Re: Joint Draft Environmental Impact Report/Environmental Impact Statement (EIR/EIS) for
East County Substation Project (State Clearinghouse No. 2009121079; DOI-BLM-CA-D070-
2010-0027-EIS (ECO SUB))

San Diego Gas & Electric Company (SDG&E) submits the attached comments to the California Public Utilities Commission (CPUC) and United States Department of Interior, Bureau of Land Management (BLM) on the Joint Draft Environmental Impact Report/Draft Environmental Impact Statement (EIR/EIS) for the proposed East County Substation Project (ECO Substation Project or Project).

Figure A-1: February 2011 ECO Substation Design

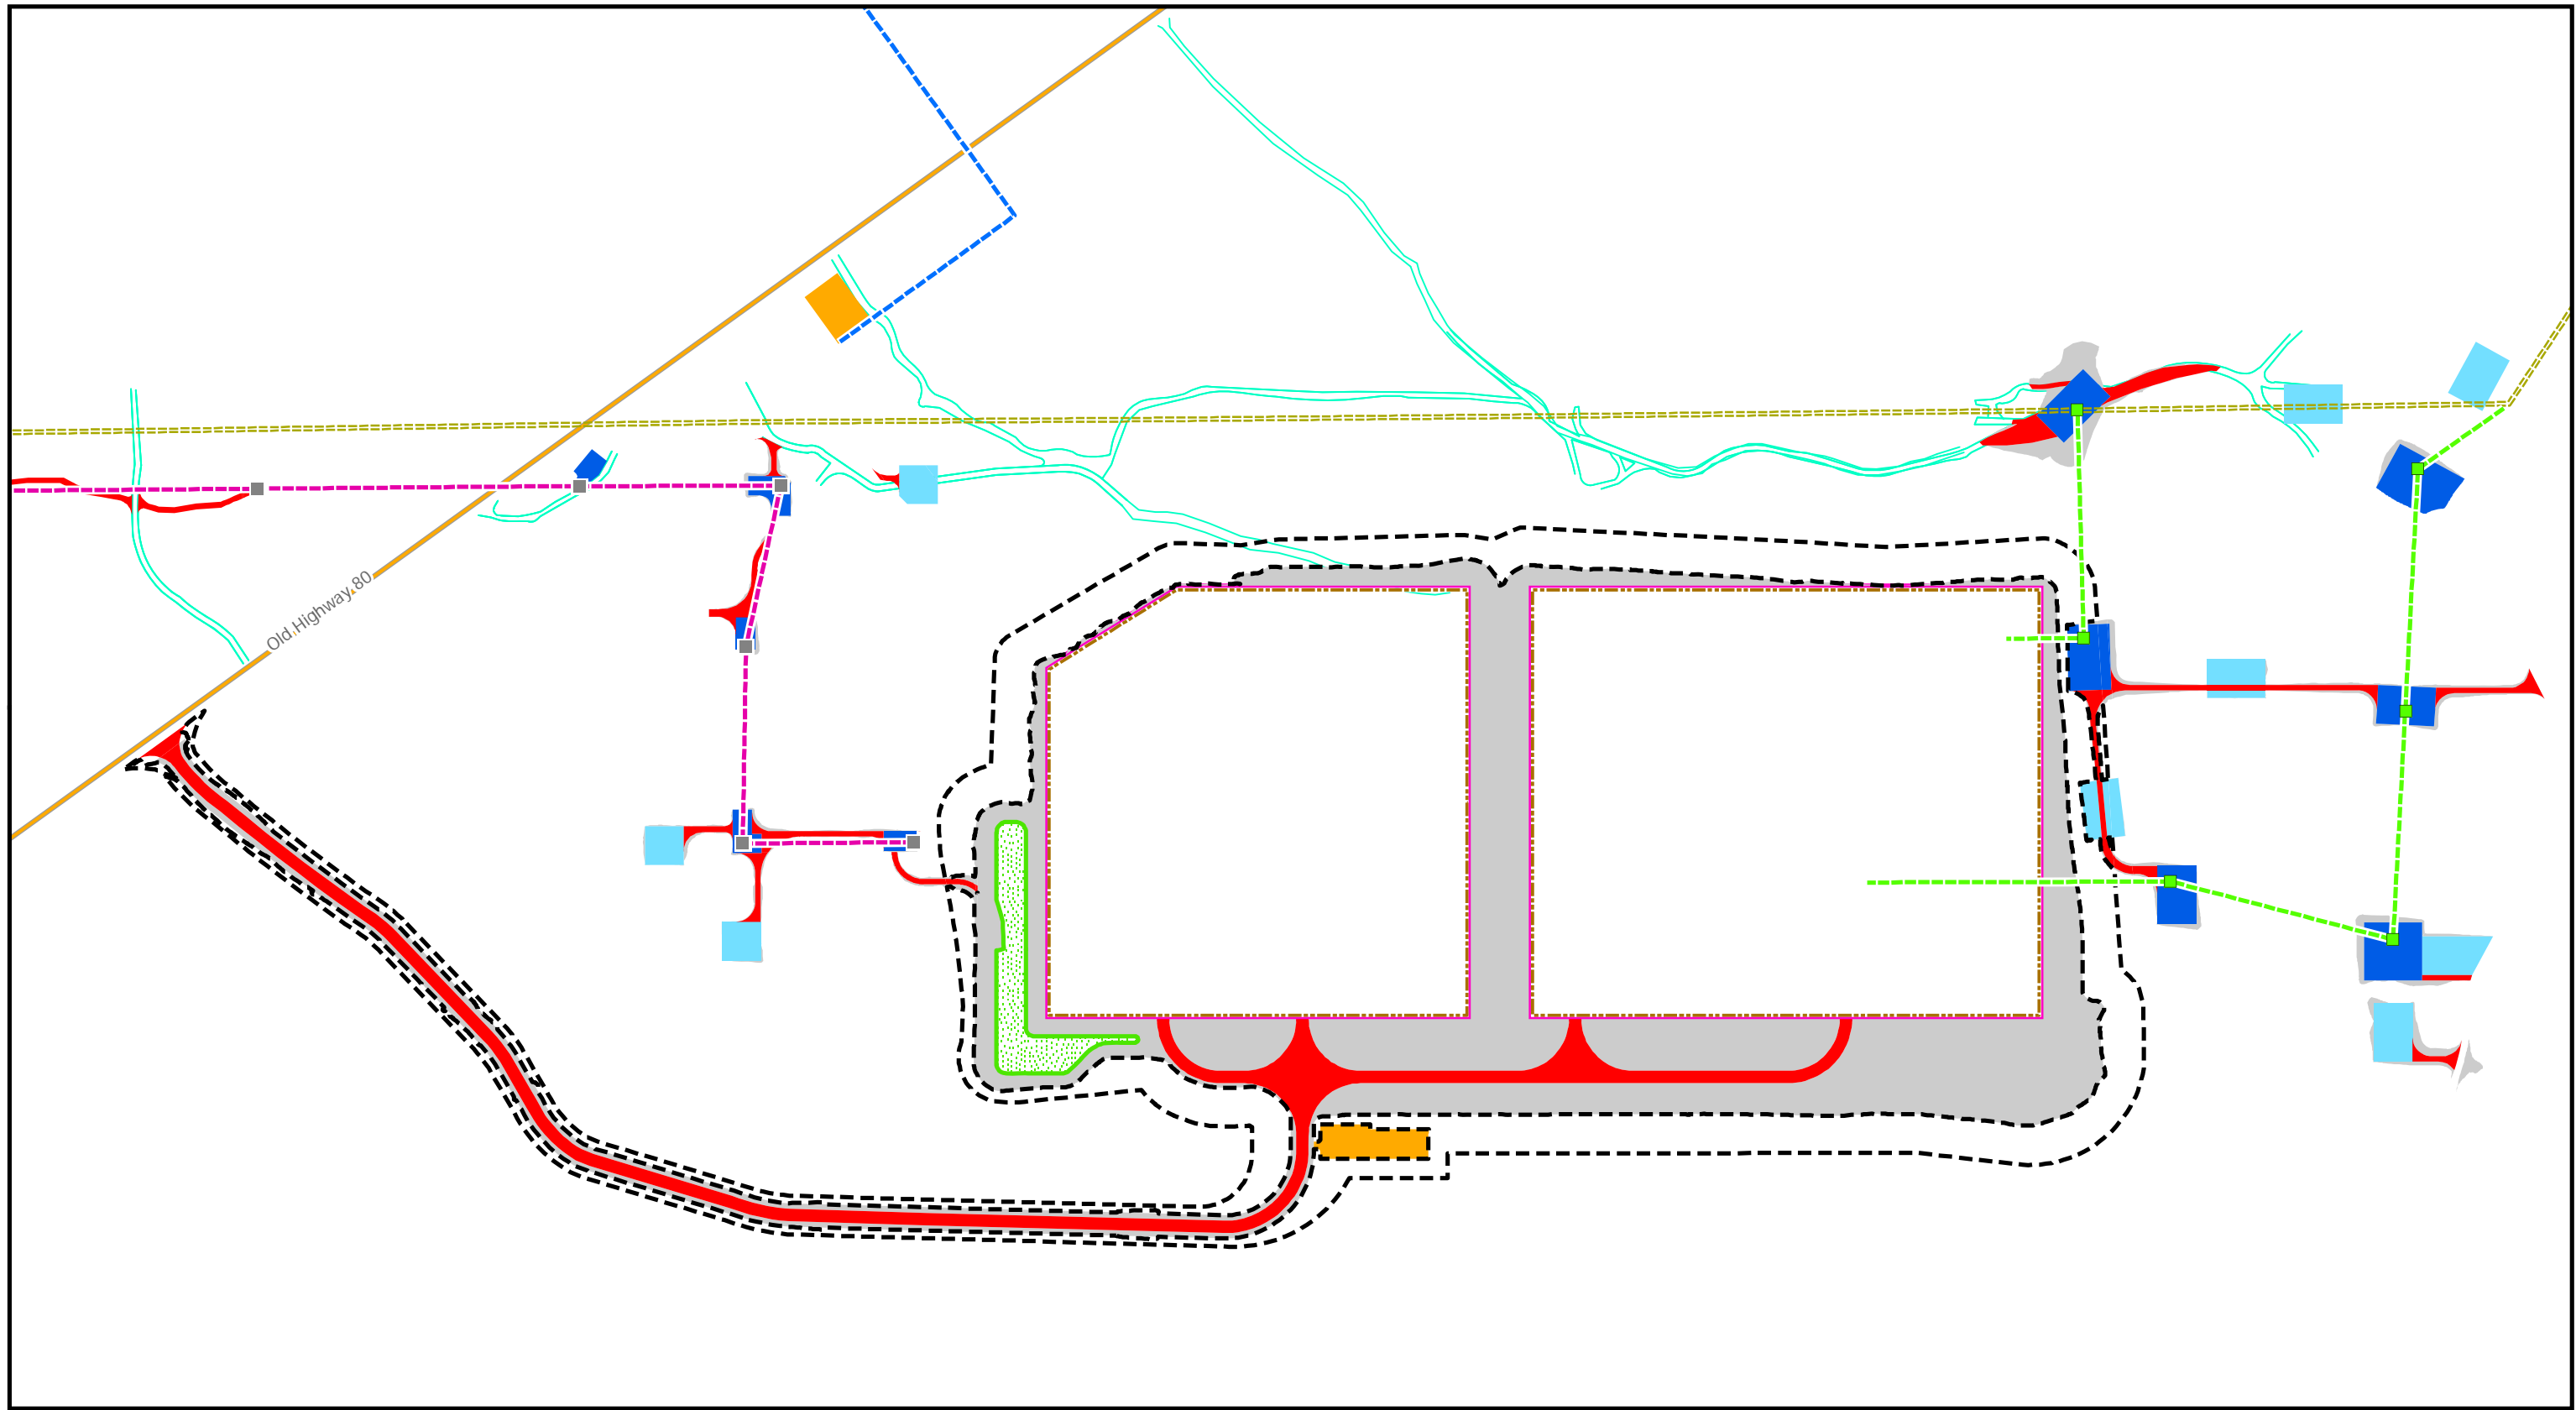
Slight modifications to the ECO Substation design were made in February 2011 for the ECO Substation Alternative Site, which is the preferred alternative location for the substation. These modifications include the addition of a staging yard north of the ECO Substation, as well as minor changes to the construction buffer and retention basin. The revisions are depicted in Figure A-1: February 2011 ECO Substation Design. New vegetation impact totals resulting from these revisions are reflected in Table A-5: Native Vegetation Community Impacts for the February 2011 Revisions, while impacts to drainages are shown in Table A-6: Jurisdictional Drainage Impacts.

- As described in the previous section—Changes to the ECO Substation Alternative Site—the retention basin for the ECO Substation was modified from 2.41 acres to measure approximately 1.00 acre in size, and the location was shifted from the northwest and western portion of the substation to the western and southwestern edge. Minor modifications have since been made to the retention basin design to better ensure proper drainage from the ECO Substation. From this revision, the retention basin will now measure approximately 1.46 acres at the bottom; the basin has sloped sides and will measure approximately 3.95 acres from the edge of the pad to the top of the slopes. The basin is still located along the western and southwestern edge of the substation, but is slightly broader along the southwestern corner.

- The construction buffer surrounding the perimeter of the ECO Substation, southern staging yard, and the southern access road has been revised based upon the changes made to the retention basin and refined engineering data. The expansion of the buffer along the south side of the ECO Substation and along the southern access road will increase the temporary buffer from approximately 17.8 acres to approximately 19.5 acres.

Figure A-2: Boulevard Substation Rebuild Distribution Drawing

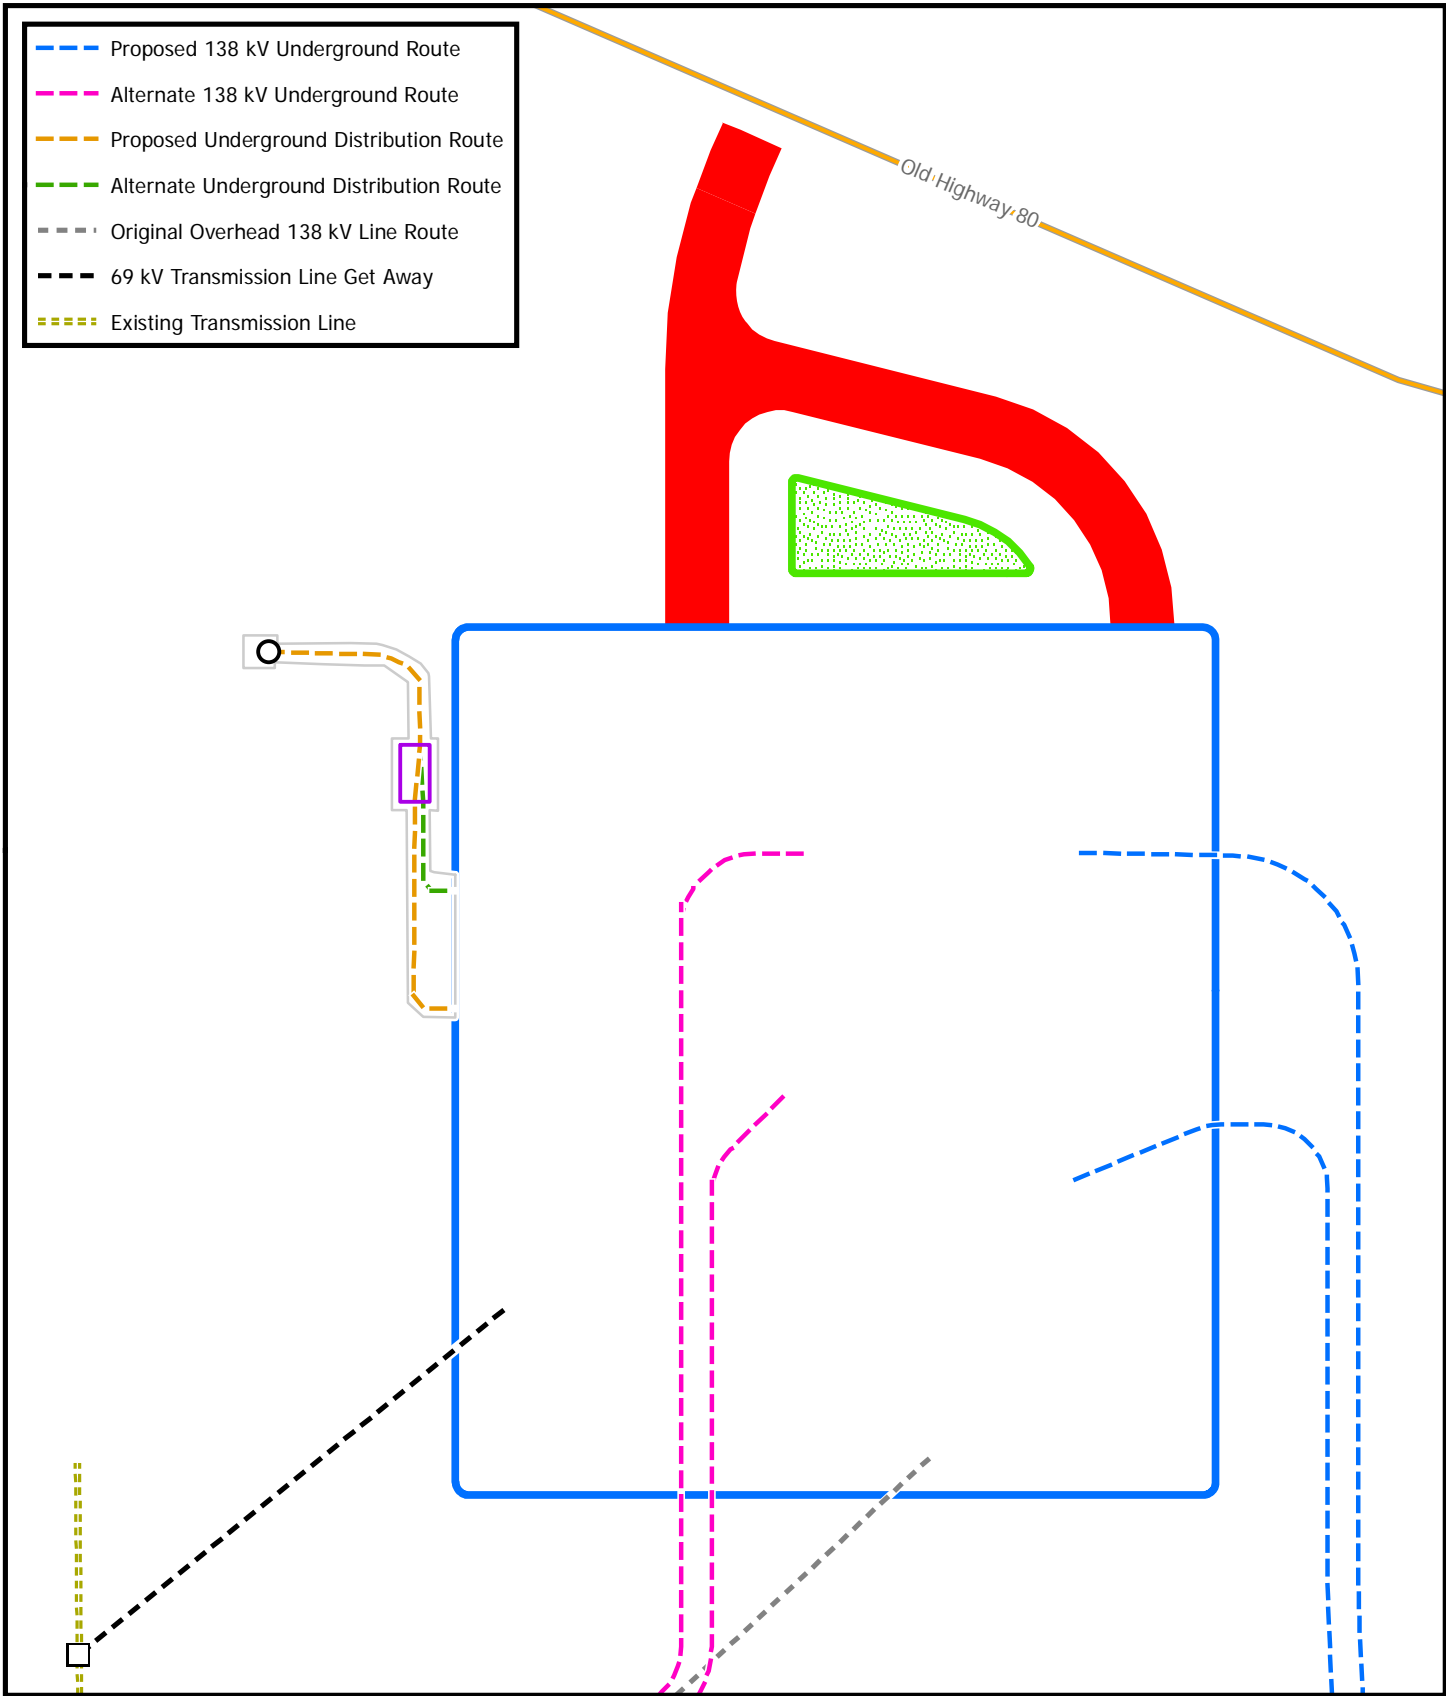
Rerouting of the distribution lines that currently enter and exit the existing Boulevard Substation will be required to connect the rebuilt Boulevard Substation to existing systems, as shown in Figure A-2: Boulevard Substation Rebuild Distribution Map. The proposed distribution reroute would exit the west side of the rebuilt Boulevard Substation through an underground duct bank carrying multiple distribution cables. At approximately 25 feet west of the existing fence line,

The underground duct would measure approximately two feet wide, and would require a six-foot-wide ROW centered on the alignment. The duct would travel from the western edge of the rebuilt Boulevard Substation to the new riser pole, a total of approximately 164 feet excluding the underground vault, with the total permanent area required for the duct package measuring approximately 984 square feet. The underground vault would require a permanent two-foot-wide ROW on all sides, for a total area of approximately 325 feet (25 feet by 13 feet). The new riser pole would replace an existing distribution pole located approximately 280 feet south of Old Highway 80, and would require a permanent workspace of approximately 100 square feet. Thus, the total permanent impacts resulting from the proposed distribution reroute would total approximately 1,409 square feet.

The alternative distribution reroute would travel in essentially the same alignment as the proposed reroute, but would exit the rebuilt Boulevard Substation at a location approximately 40 feet north of the proposed underground route. All other components for the alternative reroute would be the same as for the proposed distribution reroute. Therefore, the total area required for the alternative route would measure approximately 1,169 square feet. The proposed and alternative methods of rerouting the distribution lines to connect to the existing system are depicted in Figure A-2: Boulevard Substation Rebuild Distribution Map.
